# Rezoning Transportation Analysis

Petition Number: 2020-039

General Location Identifier: Tax ID 12709221

Date	Description
04-22-20	First Review
05-20-2020	Second Review
06-25-2020	Third Review (TV)

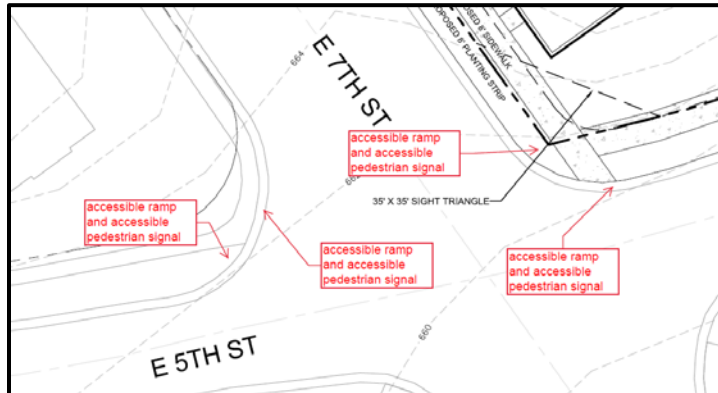
4. The petitioner should revise the site plan and conditional note(s) to commit to construct dual ramps at the corner of E 7<sup>th</sup> Street and E. 5<sup>th</sup> Street to meet the City's Charlotte WALKS Policy and PROWAG. In addition, the developer should commit to provide accessible push buttons for its corner. The site plan should label and dimension both items from the back of curb and gutter and road centerline.

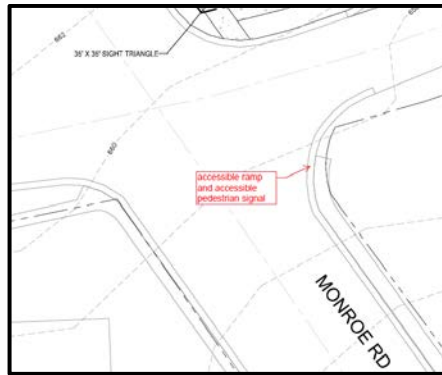
5. We request for the petitioner should revise the site plan and conditional note(s) to commit to construct dual ramps at the corner of Monroe Road and E. 5<sup>th</sup> Street to meet City's Charlotte WAKS Policy and PROWAG. The site plan should label and dimension both items from the back of curb and gutter and road centerline.
